Artcraft Addition

City Plan Commission — May, 8, 2025

CASE NUMBER/TYPE: SUSU25-00035 – Major Combination
CASE MANAGER: Saul Fontes, (915) 212-1606, FontesSA@elpasotexas.gov
PROPERTY OWNER: ASLM, LTD
REPRESENTATIVE: Conde, Inc.
LOCATION: East of Westside Drive and South of Artcraft Road (District 1)
PROPERTY AREA: 9.98 acres
VESTED RIGHTS STATUS: Not Vested
PARK FEES: \$9,980.00
EXCEPTIONS/MODIFICATIONS: Yes, see following section
ZONING DISTRICT(S): G-MU (General Mixed-Use)

ATTACHMENT 2

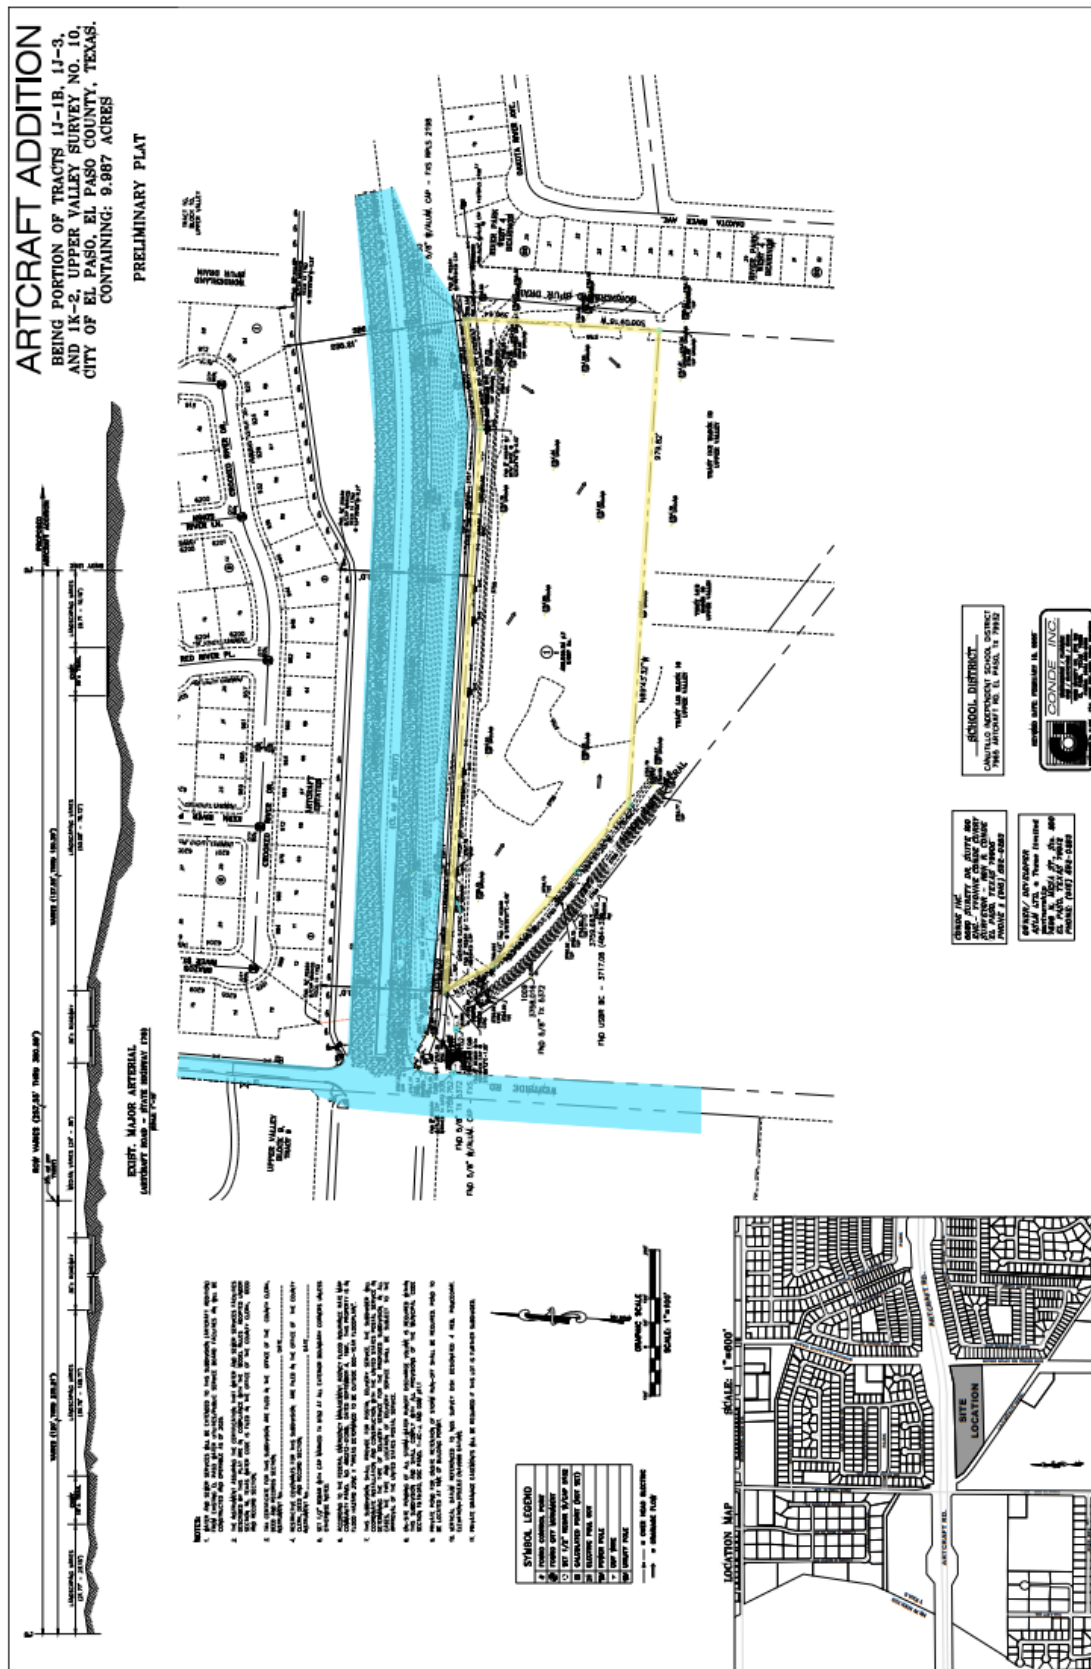
4. On the preliminary plat, provide the direction of flow of all watercourses, location, type, material, and size of any existing and proposed storm-water drainage structures and/or facilities, and provide drainage calculations.

ATTACHMENT 3

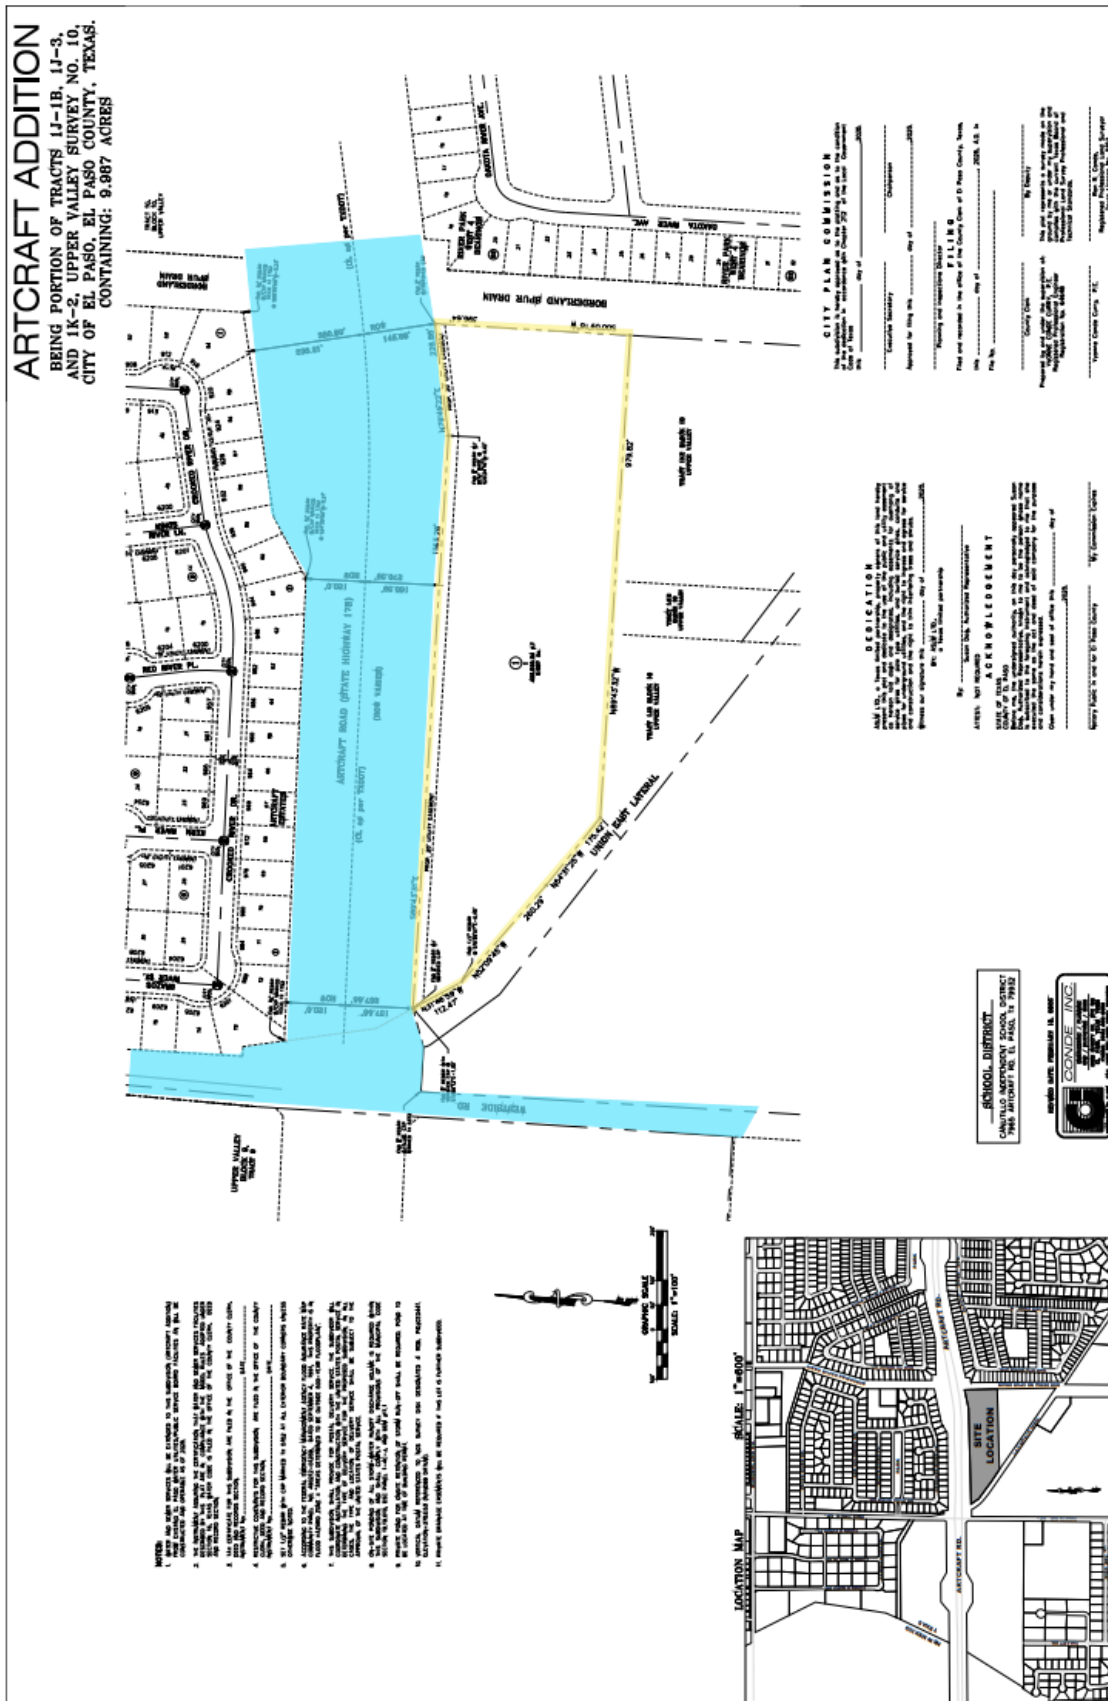
5. Remove note 4 on plat if no restrictive covenants will be provided.

1. The subdivision shall be tied to a horizontal control by bearing and distance to either a section corner, survey line, the National Geodetic Survey monument, City monument or other known and accepted survey points. This tie shall be delineated on the plats.

8. Label legal lot address.

Please change the 20' wide proposed easement to the existing 25' wide existing easement for EPE noted with instrument number **2007009715**. Please also add a 15' wide utility easement along the Borderland Spur Drain Canal for access to the lots located below the proposed lot 1 for future development.
